Agenda
Design Review Board (DRB)
July 7, 2026 at 5:30 PM
Dr. TK Gregg Community Center
650 Howard St. Spartanburg, SC 29303

PROJECT/ADDRESS/ TAX IDHome2Suites / 234 N Church St /
7-12-17-008.00; 7-12-17-008.01**PROJECT NUMBER**

DRB- 26-02000002

REVIEW STATUS – Preliminary Review**COPIES TO**

DRAWING TITLE
**ARCHITECTURAL
SITE PLAN**

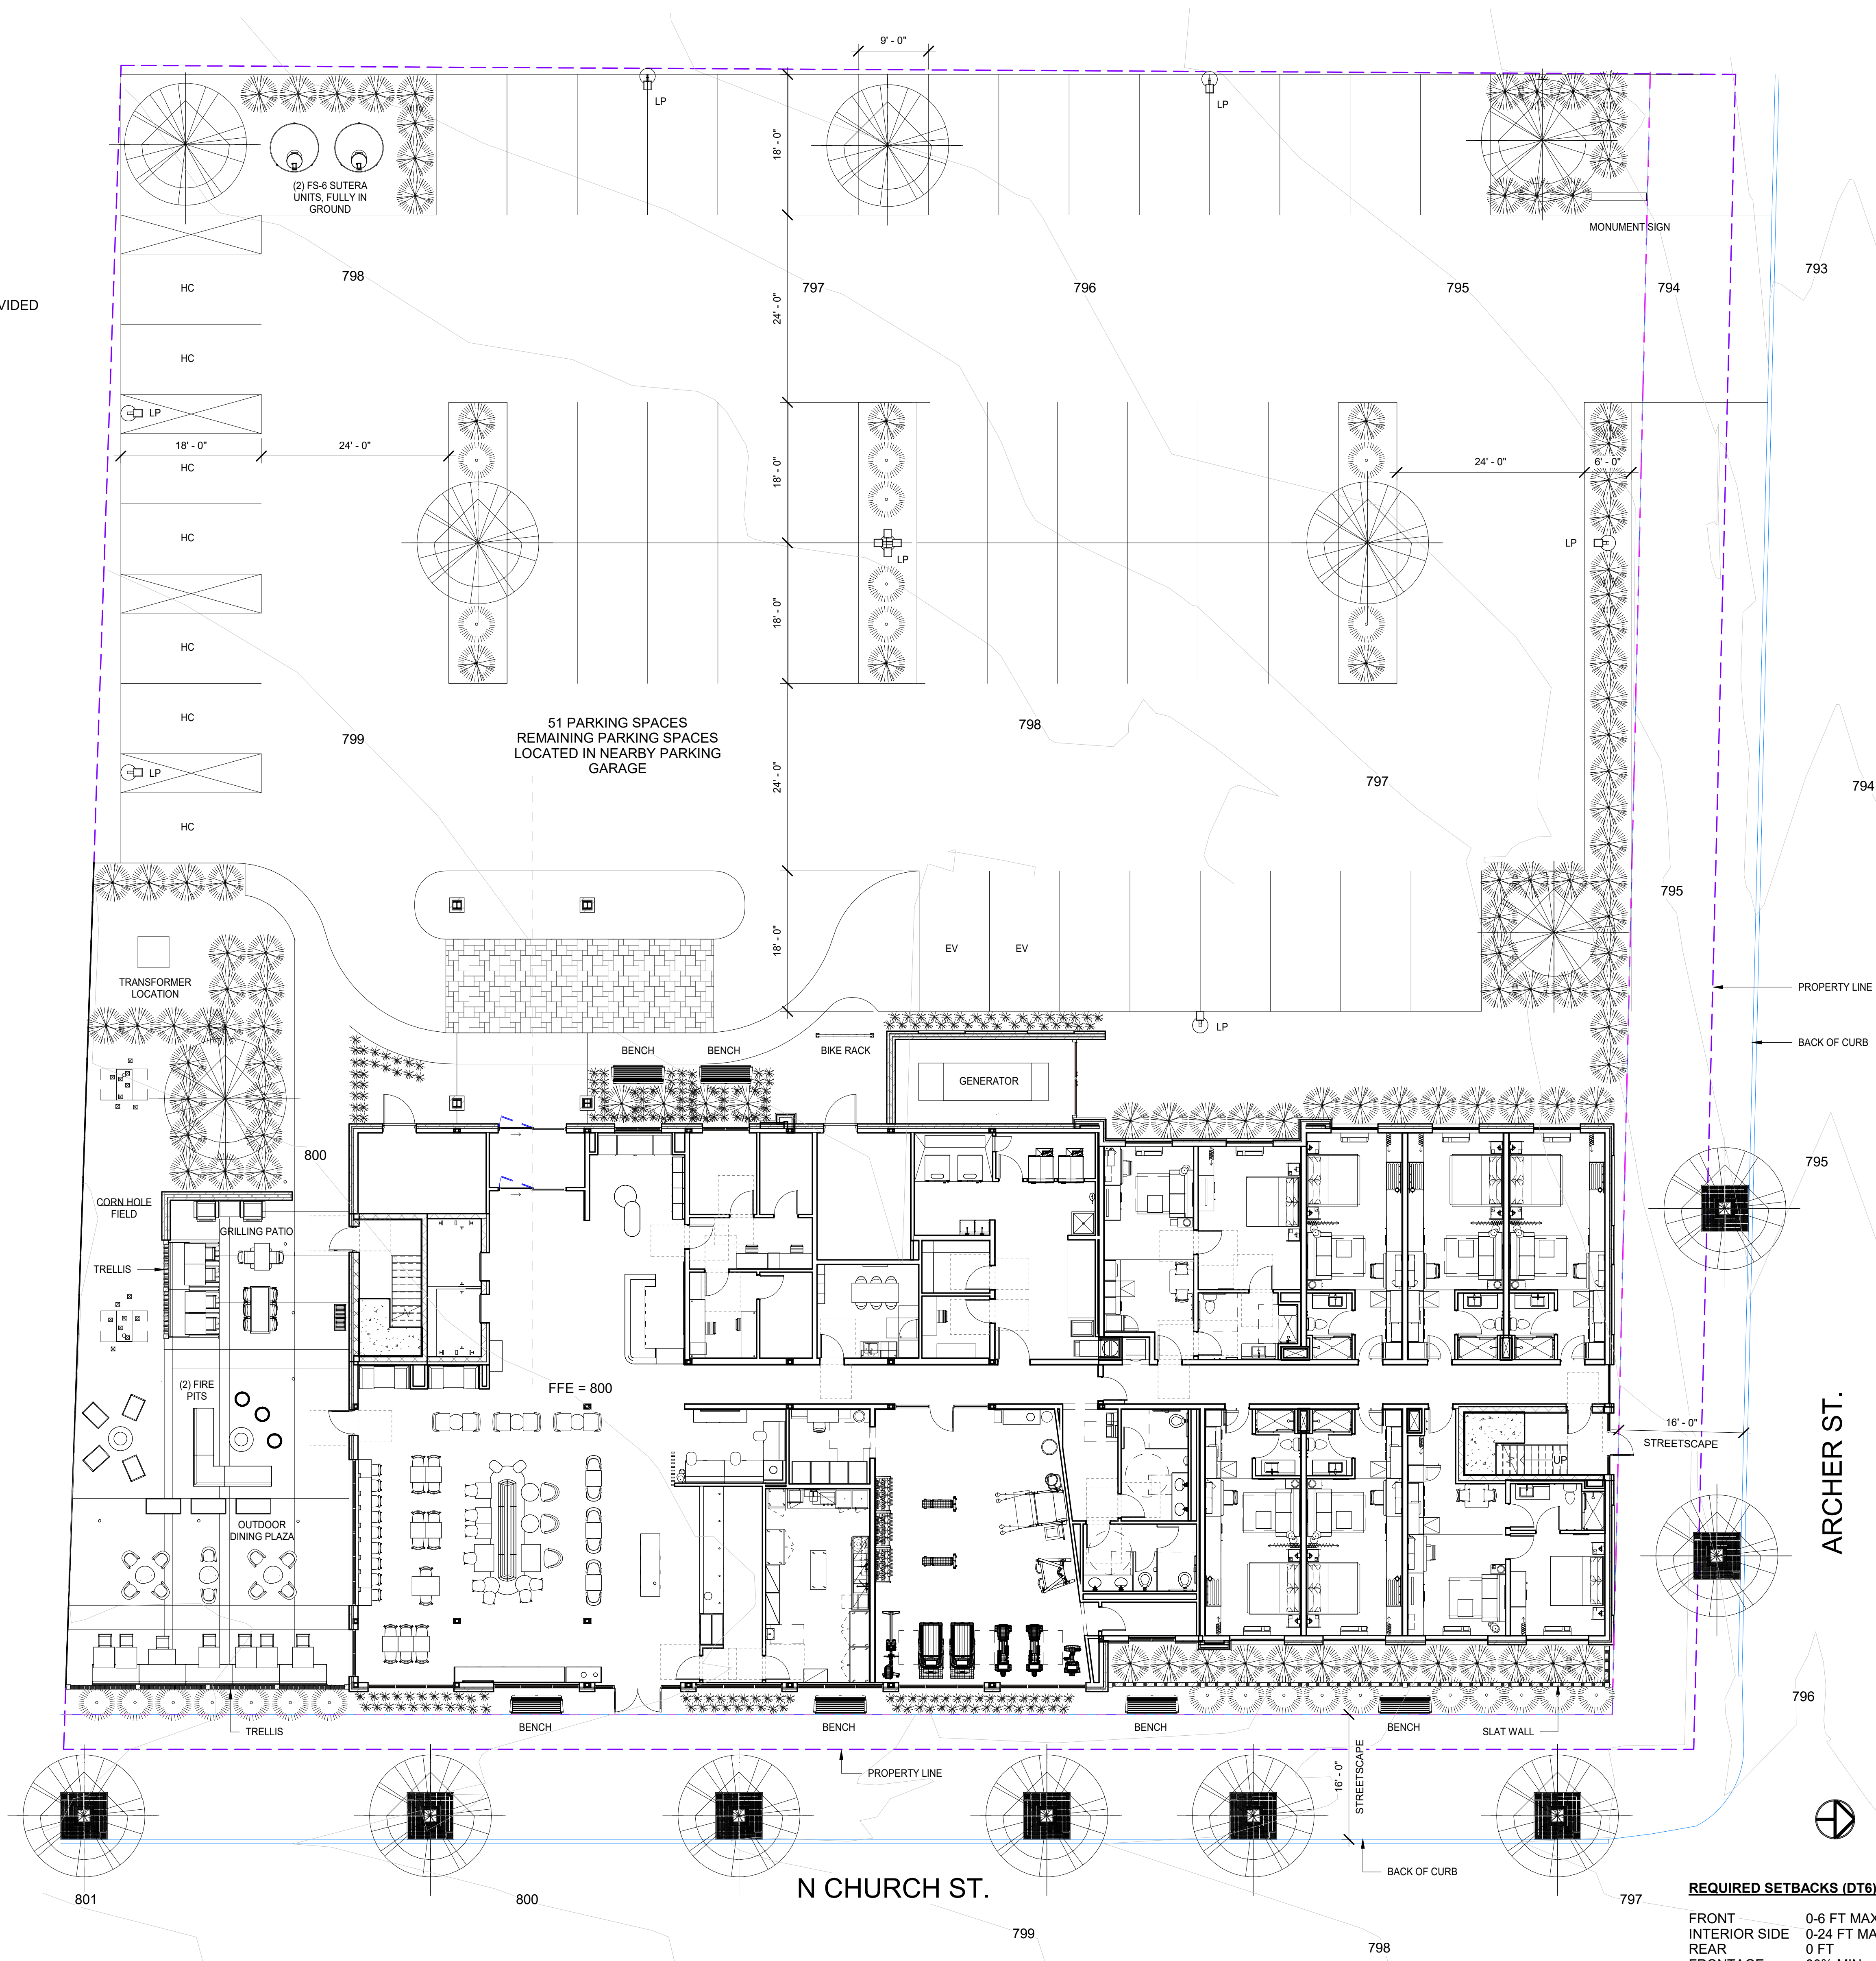
- **8.1 Required Streetscape:**
 - D-T6: 16 ft zone with 16 ft wide sidewalk and trees in wells: *Compliant*
- **8.2 Parking Area Landscaping:**
 - **8.2.1 Required Plantings:** *Compliant*
 - **8.2.2 Parking Area Screening:** *Shrubs to be maintained at 3ft minimum – Compliant*
- **8.3 Streetscreens:** *Not Applicable*
- **8.4 Fences:** *Not Applicable*

DRAWING TITLE
1ST FLOOR PLAN

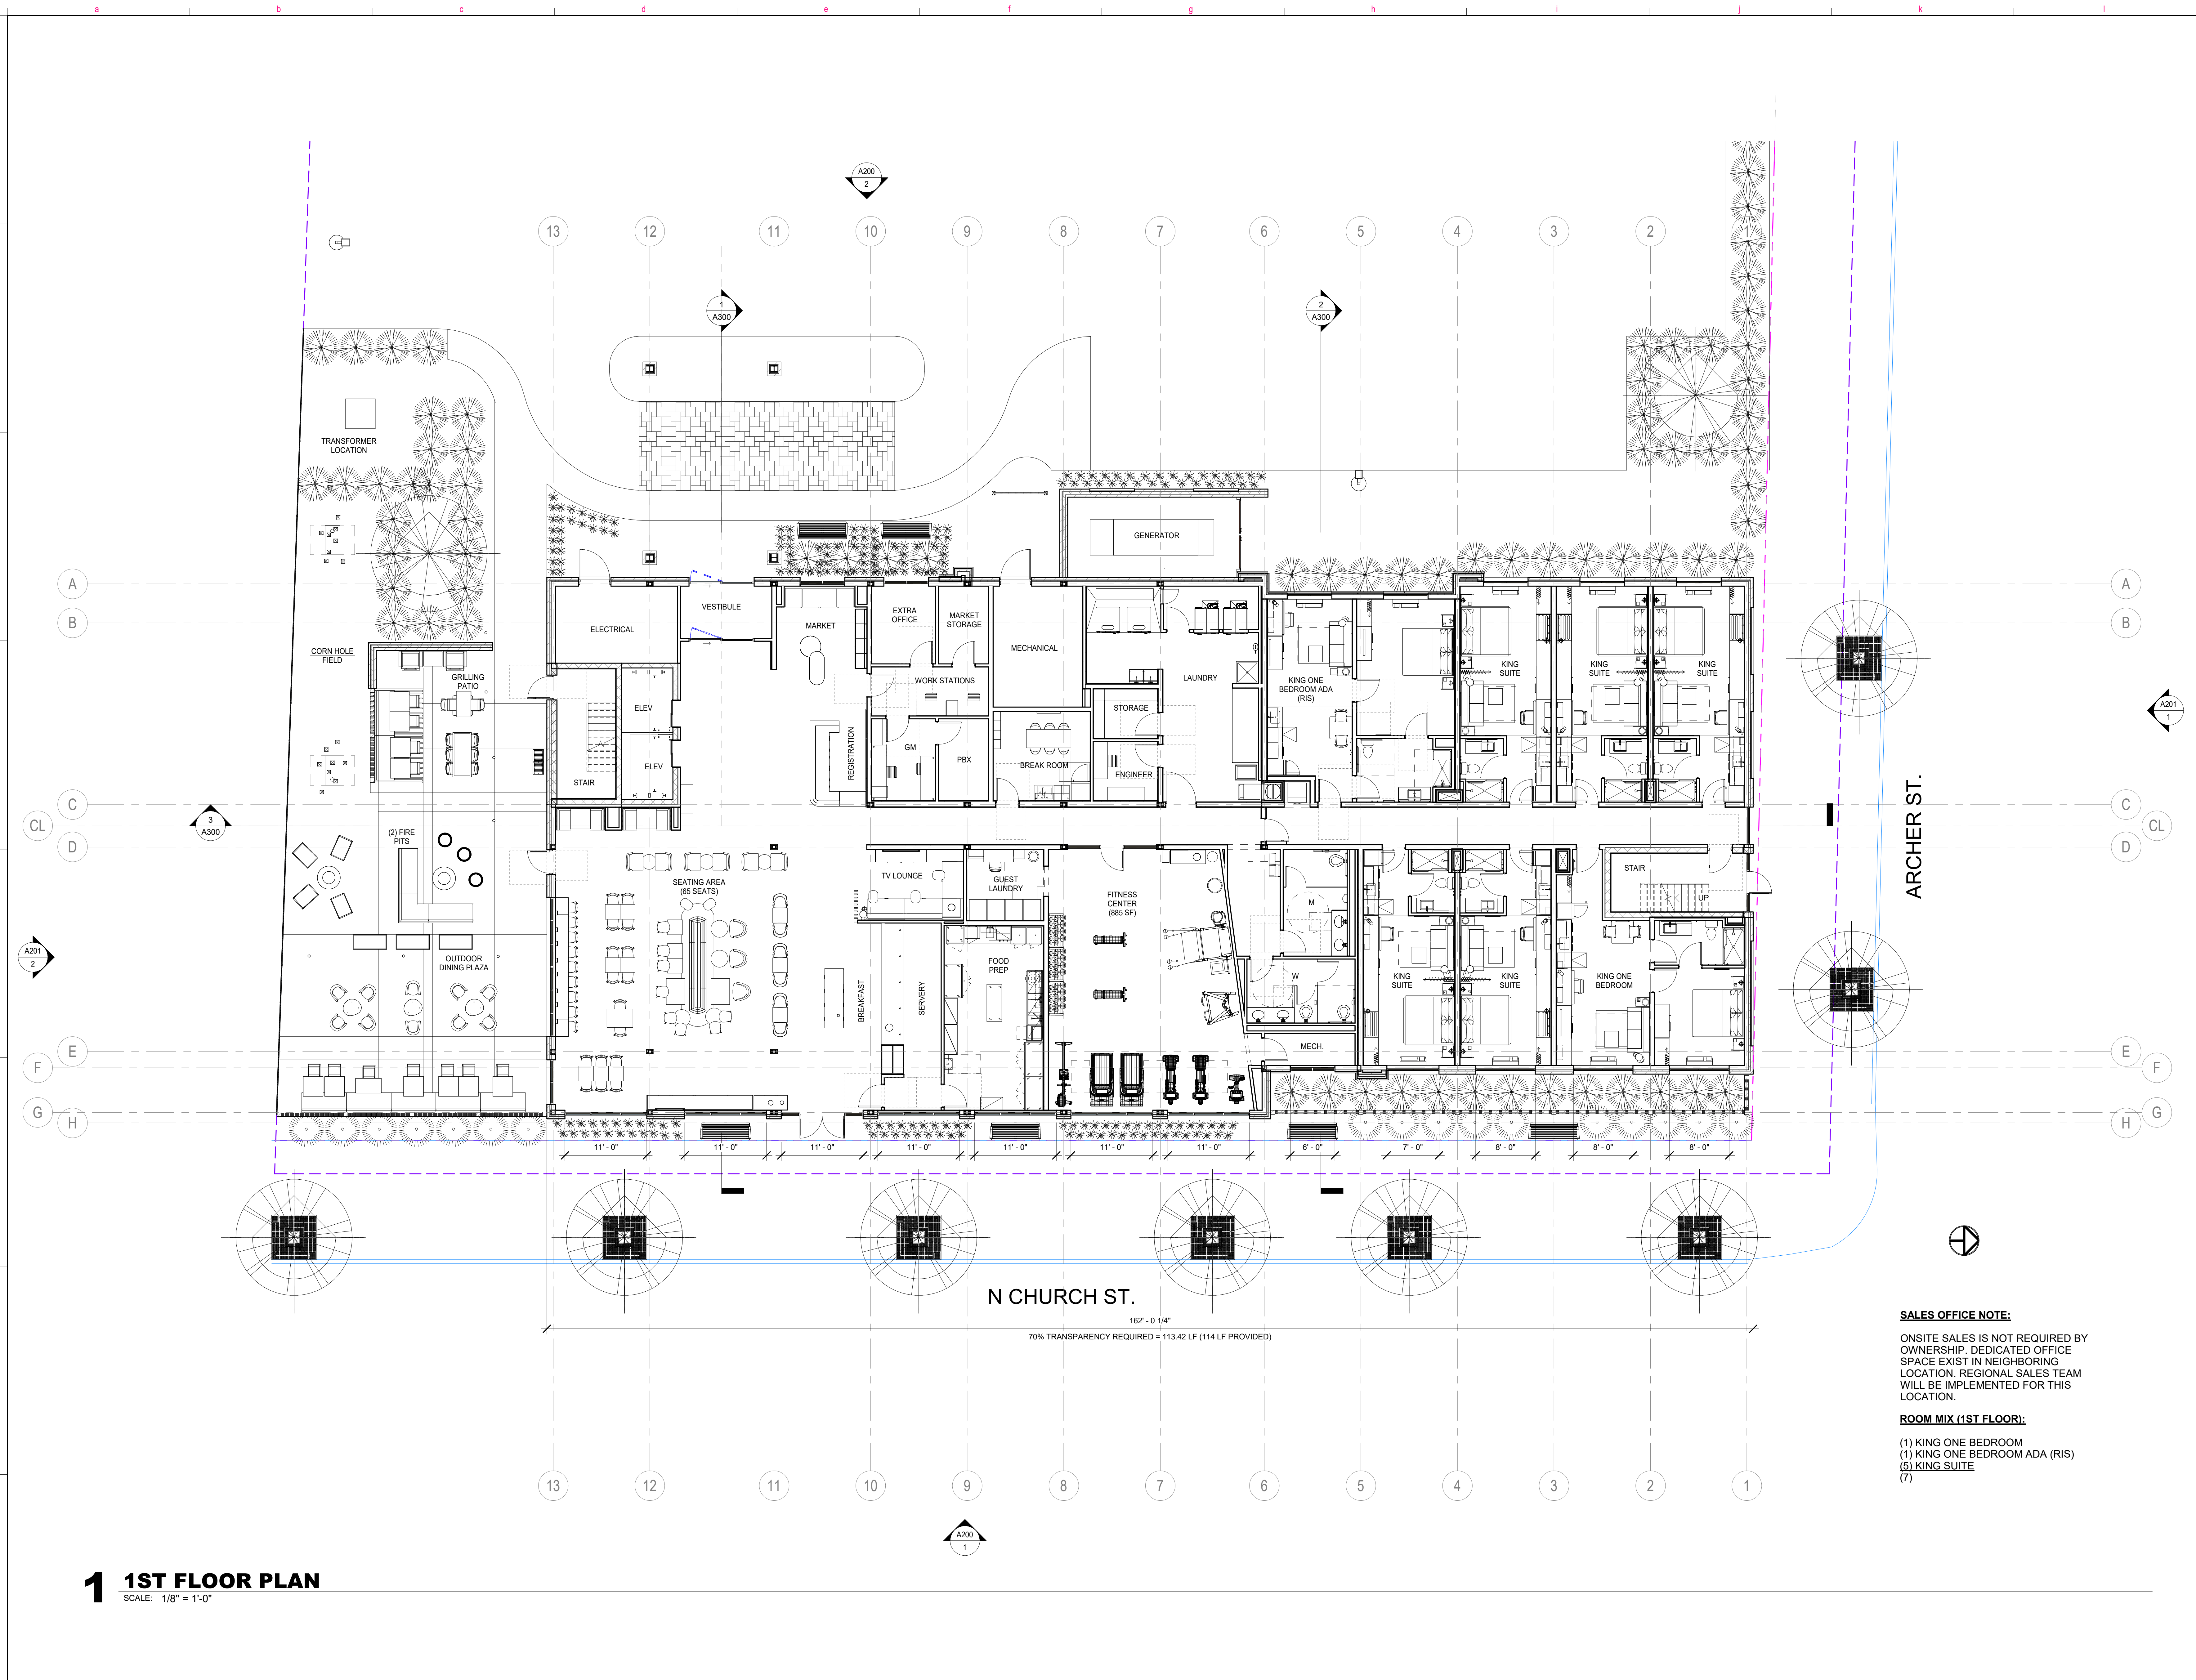
- **6.4.4 Ground Level Detailing:**
 - a. **Minimize Blank Walls:** *Compliant*
 - b. **Ground Level Glazing:** *Exception Required – all ground level windows must provide direct views to the building’s interior extending a minimum of 6 feet behind the window.*

1. Due to the intended use of the ground-floor rooms, the requirement for storefront and all ground-level windows to provide direct views at least 6 feet into the building has not been achieved at all locations. The Applicant has proposed a tiered landscape treatment that maintains the general intent of the ground-floor transparency requirement given the functional use. The Board may consider this design as an alternative measure that provides flexibility while supporting the objectives of the standard.
 2. The Applicant also proposes a warmer color temperature for the architectural and accent lighting to complement the building's architectural character. The selected lighting is intended to provide a timeless, high-quality appearance that enhances the building's design rather than relying on trend-driven lighting effects.
-
